E C O L O G I C A L R E V I E W

Raccoon Island Shoreline Protection/Marsh Creation, Phase A
CWPPRA Priority Project List 11
State No. TE-48

September 16, 2004

This document reflects the project design as of the 95% Design Review meeting, incorporates all comments and recommendations received following the meeting, and is current as of September 16, 2004.

Figure 3: TE-48, Phase A, project features.

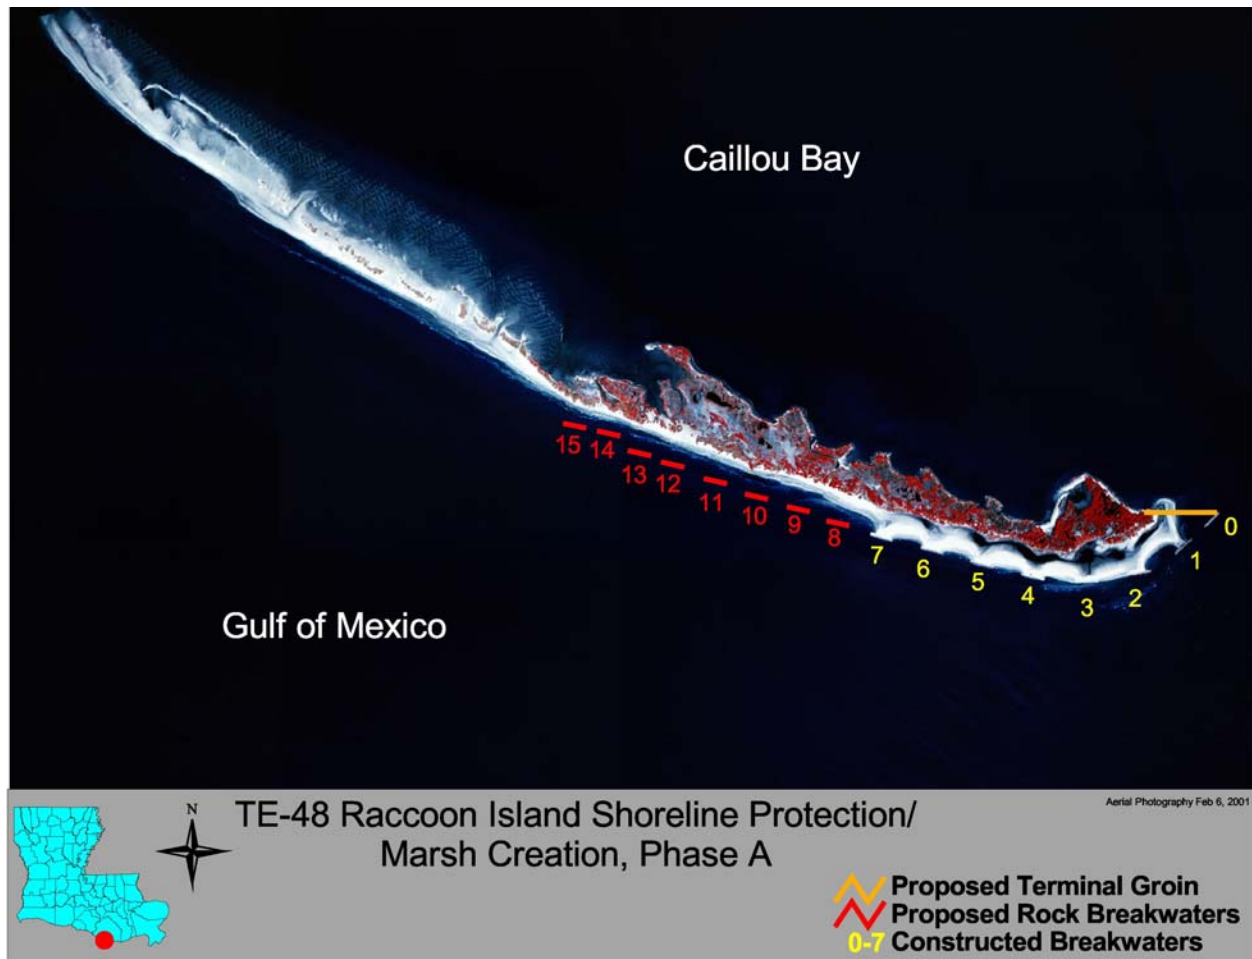
The project is anticipated to reduce the rate of shoreline erosion by approximately 60% through the construction of eight segmented breakwaters as a westward continuation of the Raccoon Island Breakwaters Demonstration (TE-29) project, and construction of a terminal groin at the eastern end of the breakwater field (Figure 3).

Eight additional segmented breakwaters will be constructed as a westward continuation of the TE-29 demonstration project. The eight, 300-foot long breakwaters will be constructed approximately 250 feet from shore, in 3 to 8 feet of water. Each breakwater will be constructed at a crest elevation of +4.5 feet NAVD-88, with a 10-foot crown and 1(V):3(H) side slopes. The gap between each breakwater will range from 160-300 feet based on results and recommendations from the sediment budget (Coastal Planning and Engineering, Inc. 2004) (Table 1).

An 952-foot terminal groin will be constructed at the eastern end of the breakwater field from the island to the end of breakwater 0, to stabilize the eastern end of the island and reduce tidal currents between breakwaters 0, 1, and 2, and the shoreline. The eastern terminal groin will be constructed at a crest elevation of +4.5 feet NAVD-88, with a 10-foot crown and 1(V):3(H) side slopes.

The development of the sediment budget enabled the design team to refine the design of the project, through the modification of the length of the gaps between breakwaters, and incorporating the addition of a terminal groin at the eastern end of the breakwater field. The design had originally incorporated a 600-foot terminal groin at the western end of the breakwater field from the island to the end of breakwater 15, to capture most of the sediment that would otherwise have passed through the breakwater field and been lost to the emergent portion of the island. The western groin would have greatly reduced the loss of sediment through longshore transport, which is predominantly east to west, and would have reduced shoreline erosion rates behind the proposed breakwater field on Raccoon Island by approximately 75% (from 52 feet/year to 12 feet/year, based on model calculations performed by Coastal Planning & Engineering, Inc. [2004]). Construction of the western groin would likely have resulted in an erosional shadow in the area to the west of the structure, caused by a sediment deficit. Because of the location of the structure at the western end of the island the emergent, vegetated portion of the project area would not have been affected; however, the sand spit located down drift from the structure would likely have been starved of sediment. After some concerns were expressed over the western terminal groin's potential impact on the sand spit, it was decided to remove the structure from the project design. This will likely result in a reduction of benefits to the project area, as the western terminal groin was expected to reduce shoreline erosion by an additional 15% (75% reduction with the groin and 60% reduction without the groin). The removal of the western terminal groin will result in an estimated increase in shoreline erosion of 9 feet/year (from 12 feet/year to 21 feet/year). This is equivalent to a loss of emergent vegetated island habitat of approximately 17 acres over the 20-year project life.

The 952-foot terminal groin that is designed at the eastern end of the breakwater field from the island to the end of breakwater 0, should stabilize the eastern end of the island and reduce tidal currents between breakwaters 0, 1, and 2, and the shoreline. This should result in the accretion of an additional 6 acres of beach, if the sediment from the shoal continues on being available (Coastal Planning and Engineering, Inc. 2004).

After review of the design of the project, the results of the sediment budget, and review of the monitoring information from previous breakwater projects in Louisiana, it is the opinion of the LDNR project team that the project will likely achieve the goal of reducing the shoreline erosion rate in the gulfside project area by approximately 60% (from 52 feet/year to 21 feet/year).

Based on information gathered from similar restoration projects, engineering designs and related literature, the proposed strategies in the Raccoon Island Shoreline Protection/Marsh Creation, Phase A project will likely achieve the desired goals. At this time, the Louisiana Department of Natural Resources, Coastal Restoration Division recommends that the Raccoon Island Shoreline Protection/Marsh Creation, Phase A project be considered for CWPPRA Phase 2 authorization.
